Application No. 10/524,244  
Reply to Office Action of June 12, 2006

**AMENDMENTS TO THE DRAWINGS**

**REMARKS**

FIG. I

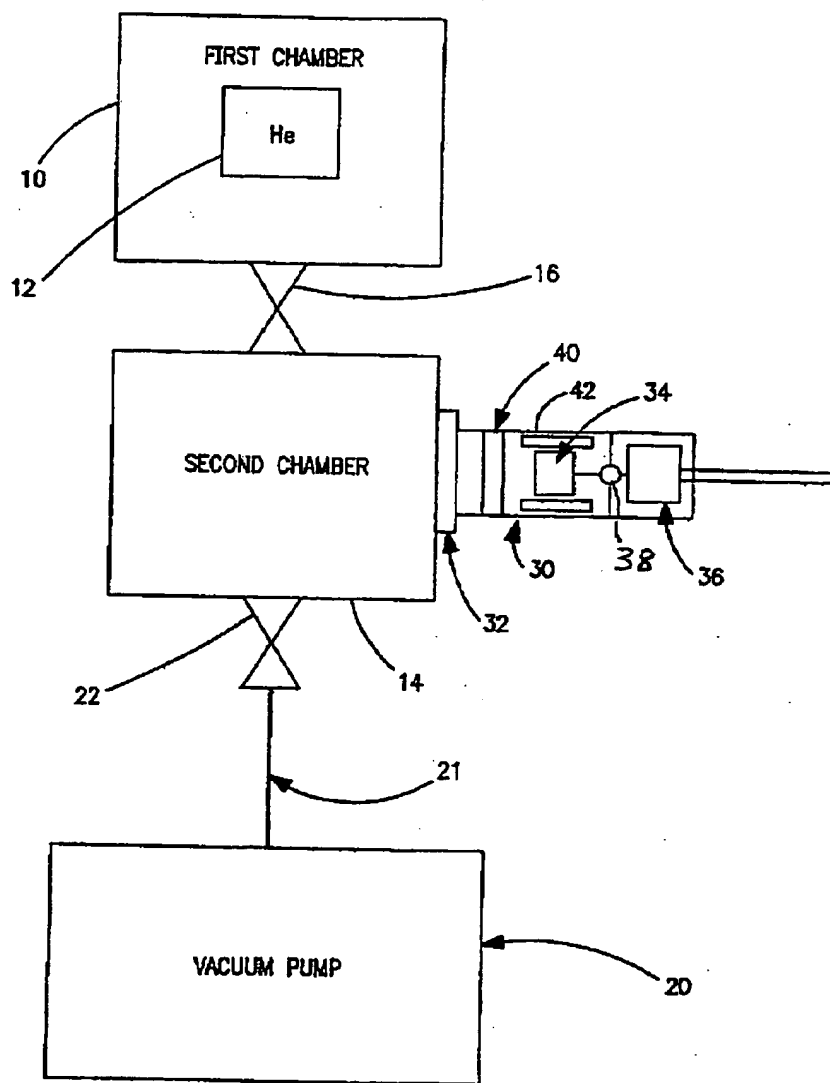
The Examiner has objected to the drawings because Fig. 5 should be designated by a legend such as prior art, because the drawings do not include reference signs mentioned in the description and because the drawings include a reference sign not mentioned in the description. Enclosed herewith are proposed amended drawings, with changes marked in red. In the amended drawings, Fig. 5 has been designated as prior art. Fig. 1 has been amended to show reference sign 38. Fig. 5 has been amended to show reference sign 236. Reference sign 50, shown in Fig. 1A, represents a heating element. The specification has been amended at page 6, line 31 to change "conduit 50" to "conduit 60," as illustrated in Fig. 3, thereby correcting an obvious error. Reference sign 60 is now mentioned in the description at page 6, line 31, and at page 7, line 3. Approval of the corrected drawings and the amendment to the specification is respectfully requested.

New Figs. 1 and 5 are attached following page 14 of this paper.
